AJHajh-20220125-ArunCrem Planning Response_LPA.docx

Y/184/21/DOC – CONDITIONS 8, 9 AND 10: DRAINAGE RESPONSE

Thank you for returning comments from your Drainage Engineer pertaining to planning conditions 8, 9 and 10 under planning permission Y/184/21/DOC for the Crematorium, Bognor.

Proposed Foul and Surface
Water Drainage Layout
(Sheet 1 of 2)

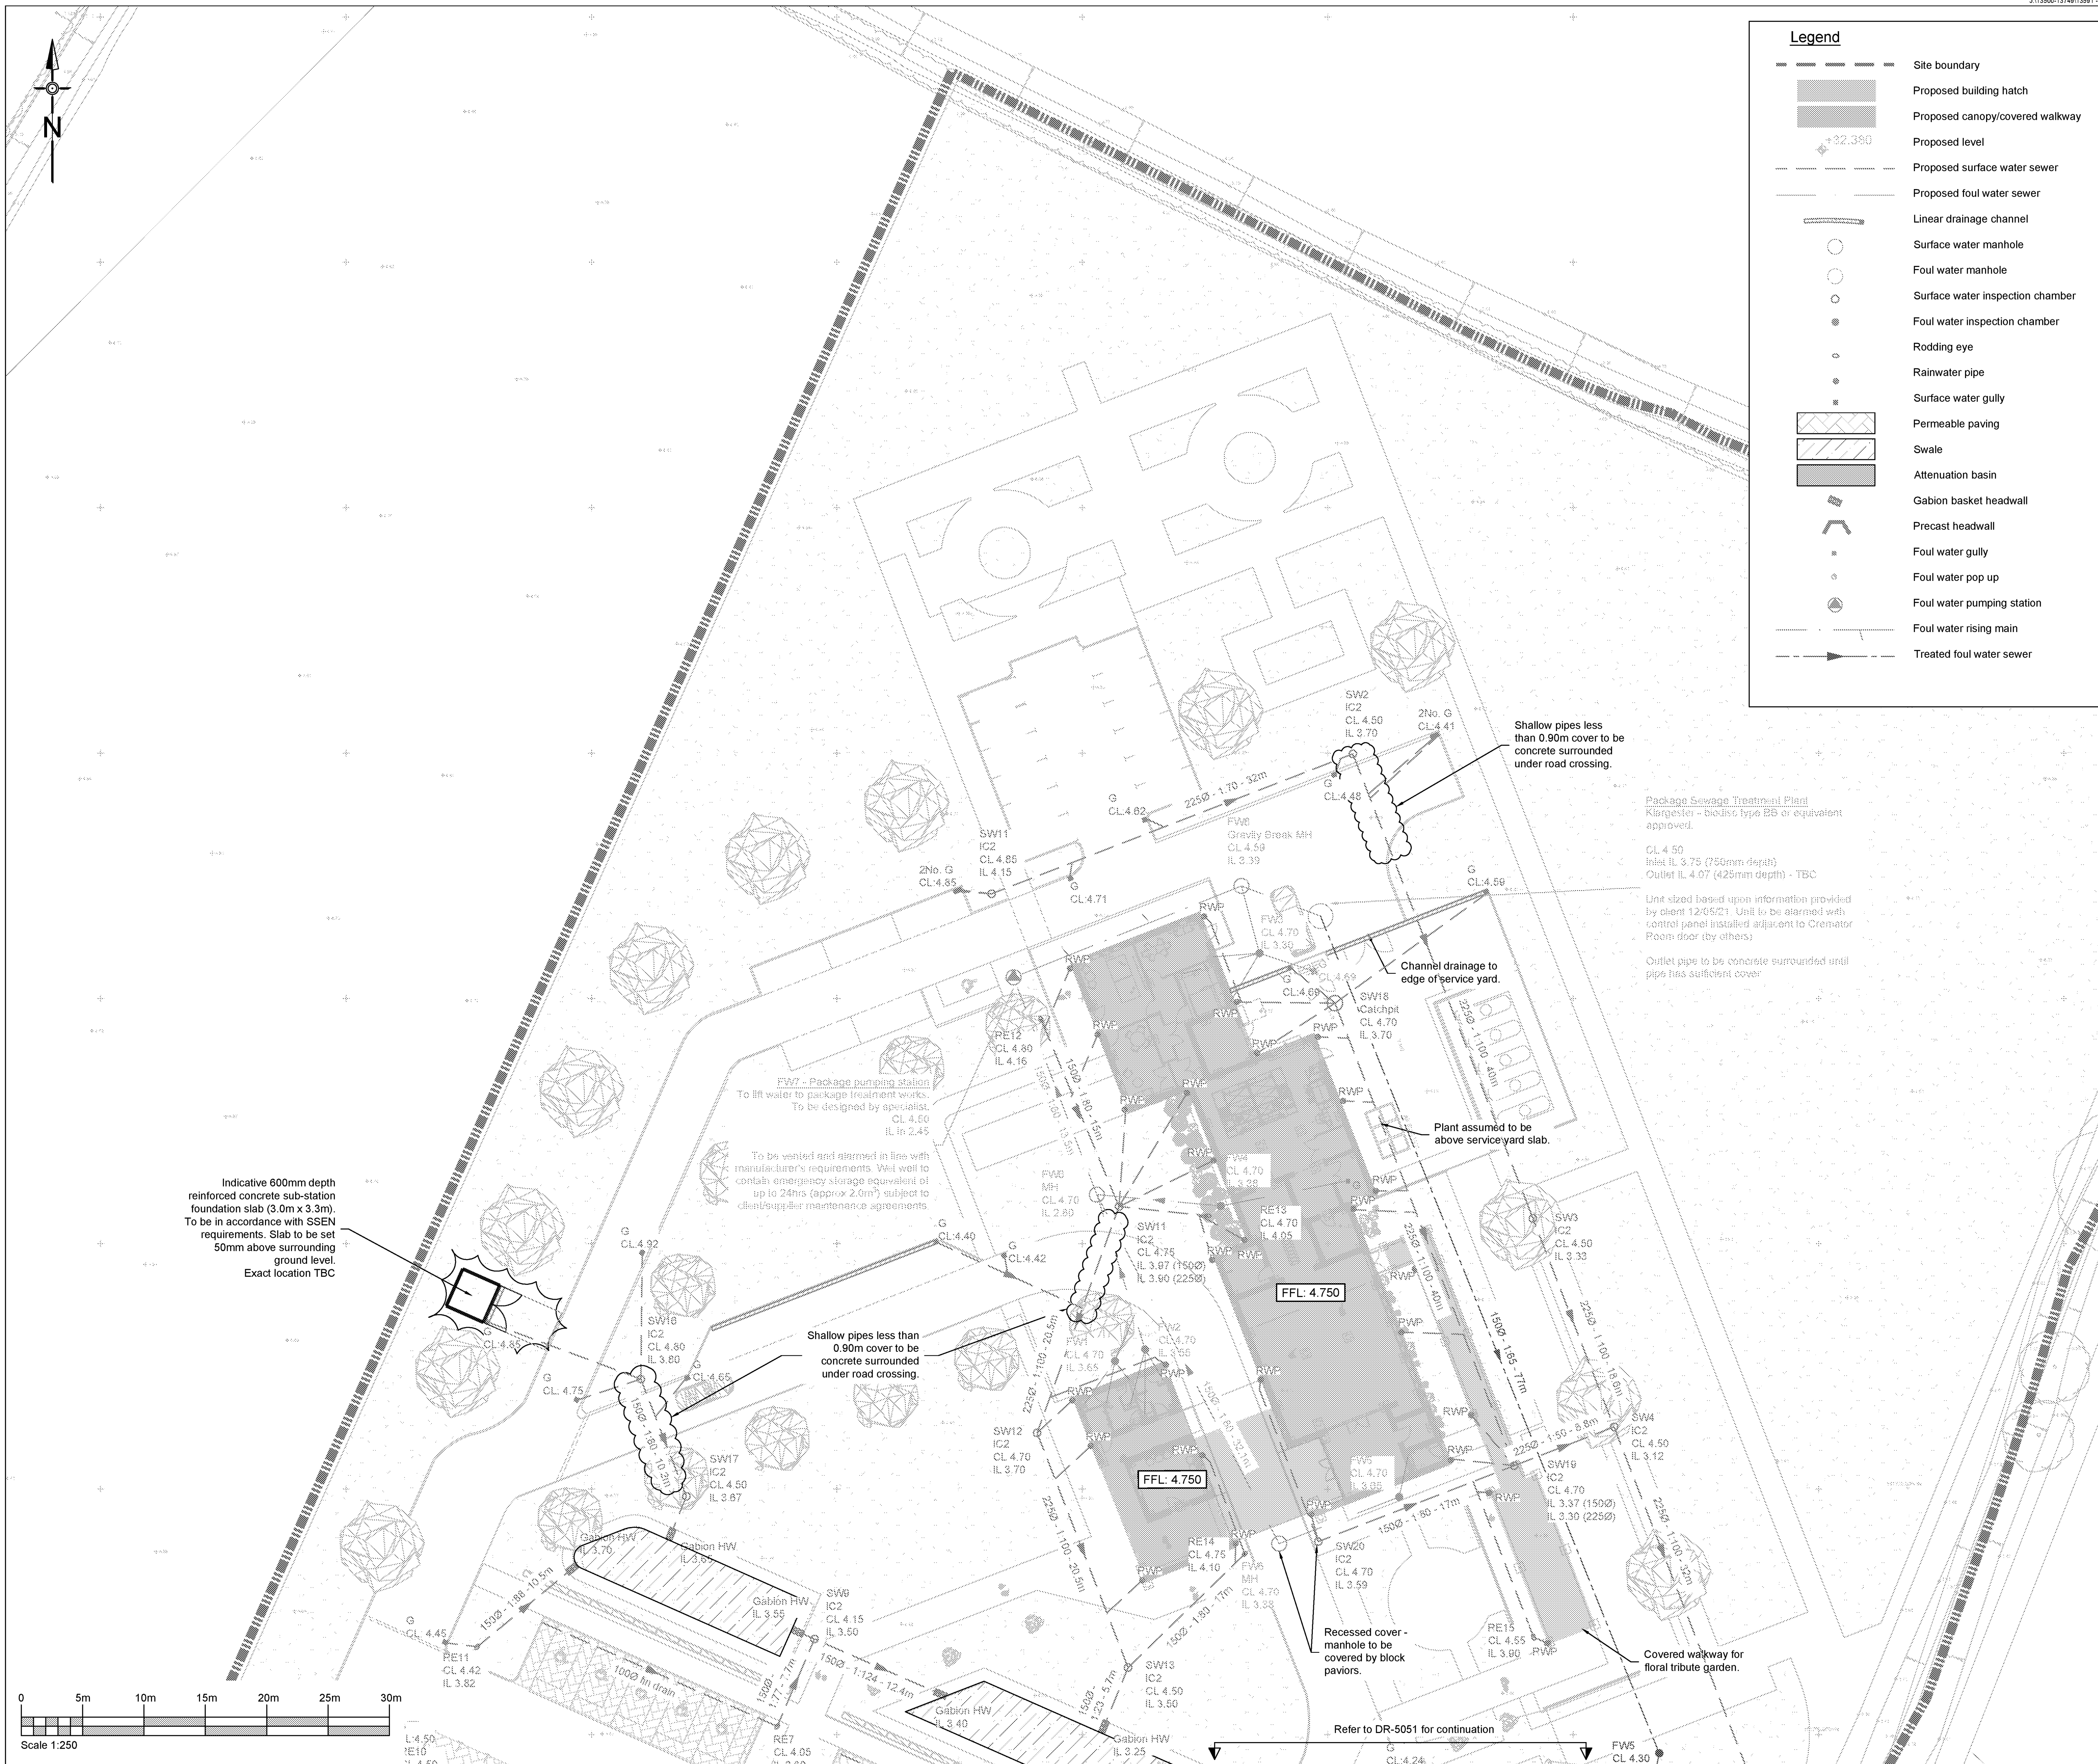
1. *Please supply results of winter groundwater monitoring and winter infiltration testing.*
2. *Please supply calculations to support design.*
3. *Please supply an impermeable area catchment plan.*
4. *Please label all pipes with diameter and fall.*
5. *Hydrobrake unit references should be included on layout plans.*
6. *Please label finish and formation level of permeable paving.*
7. *Gullies and channel drains should be labelled with cover levels.*
8. *The gabion outfall construction detail drawing is unclear. Is it proposed to have buried pipes discharging to the basin?*

3. Please see enclosed impermeable area plan 13591-CRH-XX-XX-DR-C-5250 Revision P1.
4. Additional pipe labels have been added to drainage layout plans 13591-CRH-XX-XX-DR-C-5050 Revision P6 and 5051 Revision P5. Gradients for short (<5m) pipe lengths have not been shown. Pipe sizes, maximum grades and materials are to be as specified on drainage notes drawing 13591-CRH-XX-XX-DR-C-5300 Revision P1 previously provided.

7. Cover levels have been provided for proposed gullies on updated drainage layout plan *13591-CRH-XX-XX-DR-C-5050 Revision P6* and *5051 Revision P5*. Channel drain cover levels will necessarily vary along the length and hence have not been provided. Exact levels will be determined by contractor to suit the finished levels as shown on levels plan *13591-CRH-XX-XX-DR-C-5200 Revision P3*.

Proposed Foul and Surface Water Drainage Layout (Sheet 2 of 2)

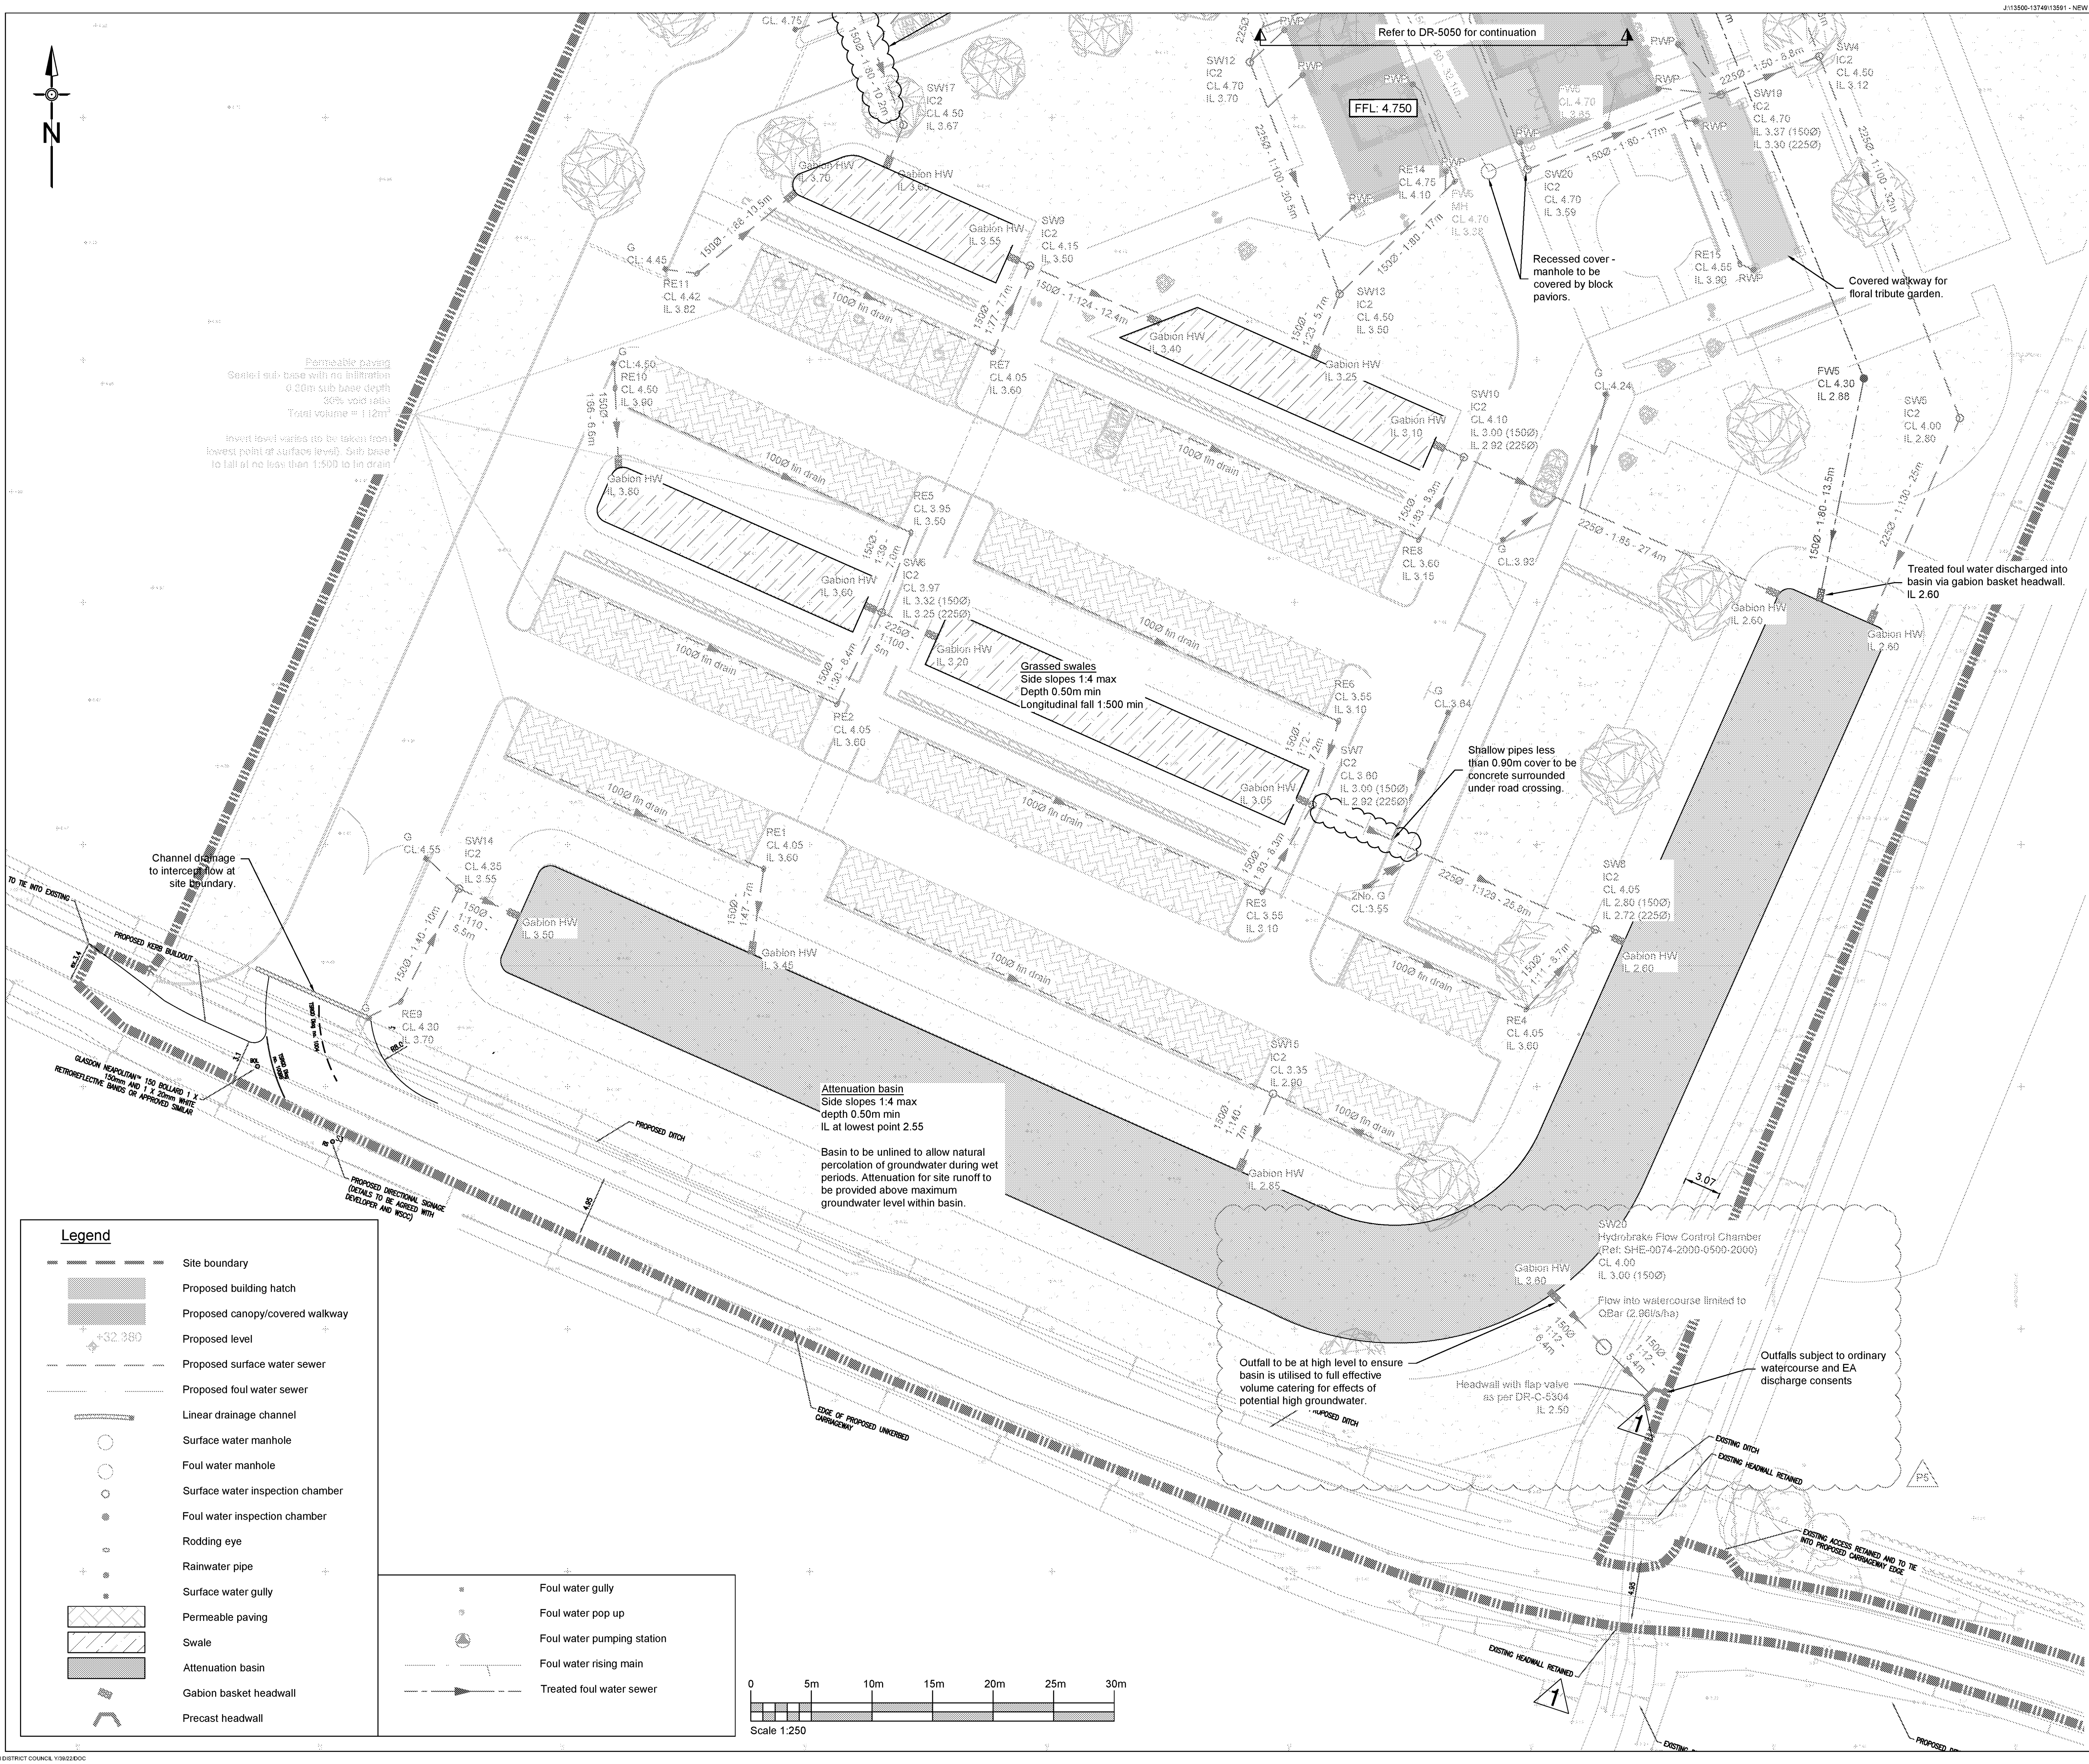
1. Please supply evidence of consent applications for the new ditch, and headwall to the existing ditch.
2. Please supply a buffer plan to show that at least 3m is being provided between top of bank of watercourses and obstructing features, such as fences, buildings, and basins.

5. Details have been added to updated drainage layout plan 13591-CRH-XX-XX-DR-C-5051 Revision P5.
6. Permeable pavement details have been previously provided on detail drawing 13591-CRH-XX-XX-DR-C-5350 Revision P2. This includes depths of proposed pavement build-up. The proposed surface levels can

1. OWC application for the discharge headwall from the basin was formally submitted in September 2021 together with all information requested by Paul Cann as per his email of 11th August 2021. Referring to Land Drainage Act 1991 Section 23(3), could you please confirm when consent letter will be issued?
2. The OWC consent for the new ditch is as shown on the attached consent (Consent Number LDC/ARUN/2021/015)
3. A suitable buffer has been provided between top of basin and edge of watercourse to allow for maintenance, as shown on drawing *13591-CRH-XX-XX-DR-C-5051 Revision P5*.
